176-16-CA

411 N EAST STREET

Nature of Project:
Deconstruct enclosed
rear porch; construct
new 2nd level rear addition;
construct rear screened porch.

RE: 176-16-CA (411 N East Street)—Approved as Amended with Conditions

**REAR (WEST) ELEVATION
PROPOSED**

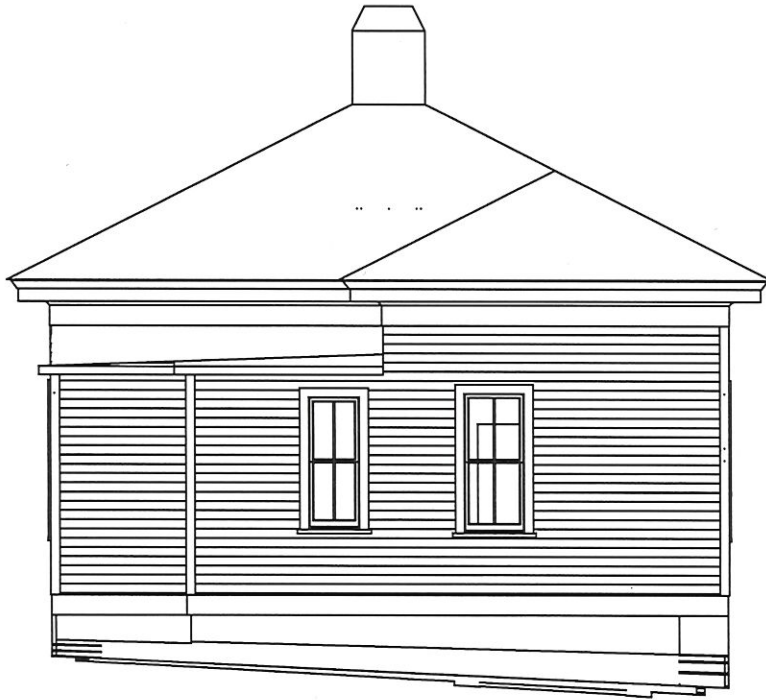
1. *That the 365-day delay be waived for removal of the tree and that a replacement tree be planted.*
2. *That the additions be revised so that they do not obscure the pyramidal form of the historic roof and that the revised drawings be provided to and approved by the commission prior to issuance of the blue placard.*
3. *That details and specifications for the following be provided to and approved by staff prior to construction/installation:*
 - a. *New windows;*
 - b. *Window and door trim;*
 - c. *Siding reveal;*
 - d. *Roofing.*

Attached, please find the updated drawings for the proposed addition on my house at 411 N East St. I have modified the addition roof as to leave a return detail for the pyramid hip demonstrating the original pyramid hip structure.

I did not realize until further evaluation that the original roof has a hip return on the opposite, where the pyramid hip intersects with the gable roof for the back portion. I noticed this on the satellite view and then verified this in person. This will be mirrored on the addition side as noted above to satisfy the conditions set forth by the COA board.

**REAR (WEST) ELEVATION
PROPOSED**

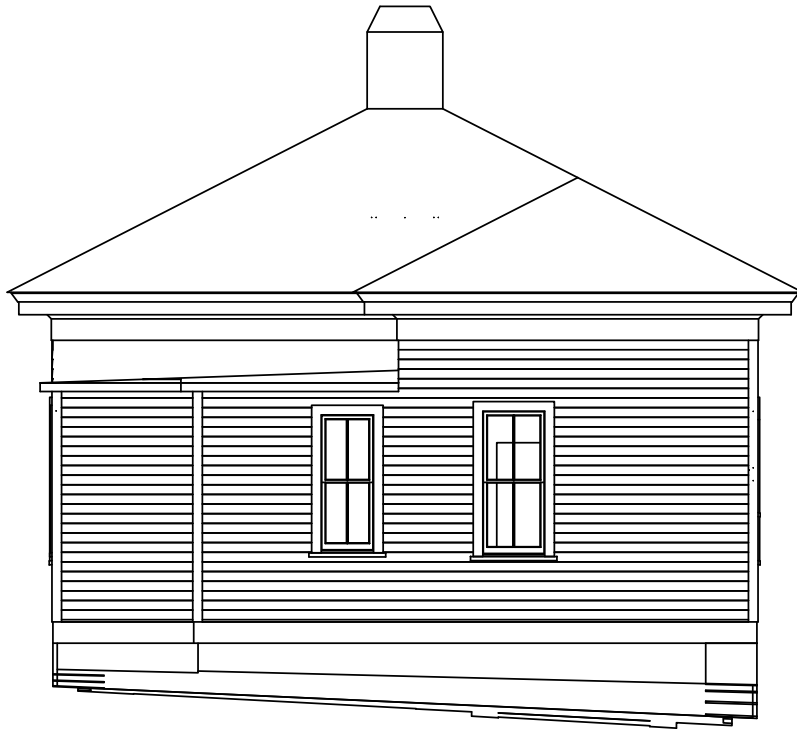
Mr. Thiem noted that as he was looking at the rear west elevation and he noted there looks like an incomplete end of the roof that was not fully detailed. Ms. Tully noted it depends on how that applies to the proposed addition, such as the proportion of the windows.
